File: NG-3514

Serial: NG-74-692

H. B. Robinson Unit No. 2
 License DPR-23

Additional Information in Support of 2300 Mwt Upgrading

H. B. ROBINSON - CONTAINMENT OUTLINE

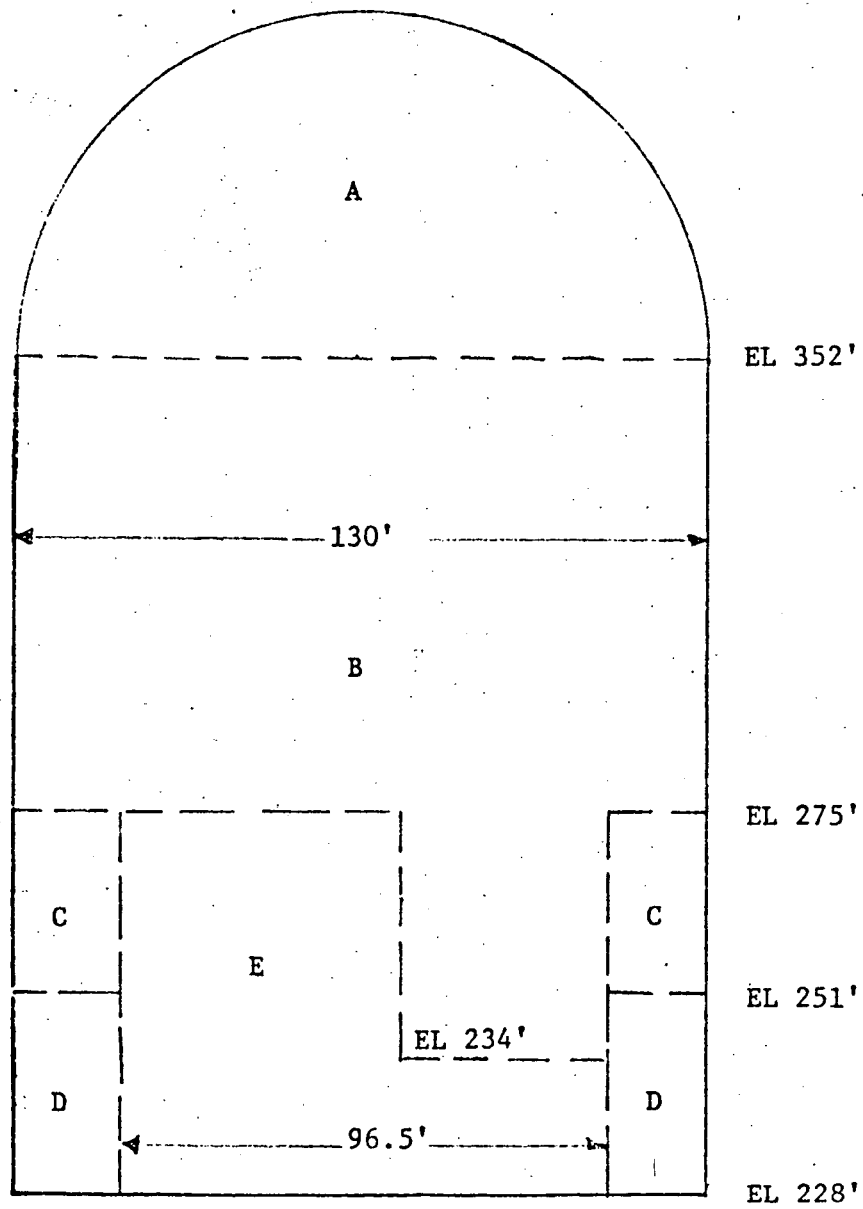
The staff requested additional information concerning the operation and performance of the core spray system during the post-accident phase, as well as a calculation of containment volumes reached by the spray and an evaluation of the effectiveness of forced mixing in compartments not directly contacted by the spray droplets.

The containment volumes for each region of the containment is presented below. The corresponding letter designation for each region is obtained by reference to the attached figure. Also presented is the information concerning forced mixing in each of the regions.

<u>Region</u>	<u>Volume (ft³)</u>	<u>Air Changes/hour</u>
A	5.78 x 10 ⁵	0
B	9.94 x 10 ⁵	7.8
C	1.35 x 10 ⁵	5.3
D	1.28 x 10 ⁵	1.65
E	2.64 x 10 ⁵	27.0

The air change information is based on a study of the fan cooler system, and assumes that only two out of the four fan coolers (each rated at 65,000 cfm) are operating. Thus, forced mixing in the containment and especially in regions C, D and E, which see somewhat less than full penetration by falling spray droplets, is considered to be sufficient to allow the complete containment atmosphere to be affected by the iodine removal capabilities of the spray.
